Proposed Waitaha Hydro Scheme

PEER REVIEW

**APPLICANT'S ASSESSMENT OF NATURAL CHARACTER,
LANDSCAPE AND VISUAL AMENITY EFFECTS**

Prepared for Department of Conservation:

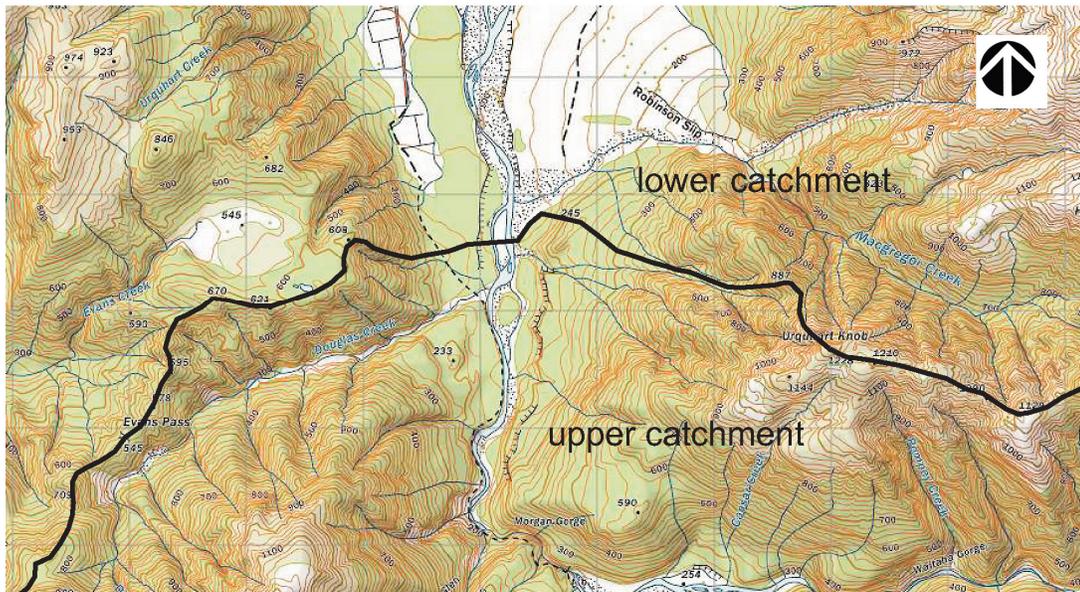
An issue raised in the Isthmus review argues that the line of demarcation between the upper and lower catchments could be mapped differently. Put simply, the upper catchment including the gorge is found by both Messrs. Lister and Bentley as likely to meet the requirements of an ONL, while the lower catchment is by contrast settled and farmed, and therefore less natural. The range pierced by the Morgan Gorge at a broad landscape scale provides the division between the two catchments and resulting different landscape character areas.

The Isthmus report suggests that the mapped line of change could be moved closer to the proposed powerstation site which infers that the more enclosed gorge topography might be a better change point. However Mr Bentley has re-examined his assessment of this line and has decided to retain it as is⁴. I agree with Mr Bentley's opinion and I favour his more conservative approach. The landscape

Perhaps a third option for locating a catchment demarcation line would be to consider the Macgregor Creek sub-catchment as forming the boundary which would be topographically easy to define, and would still be close to Mr Bentley's Urquhart Knob spur division line (see diagram above).
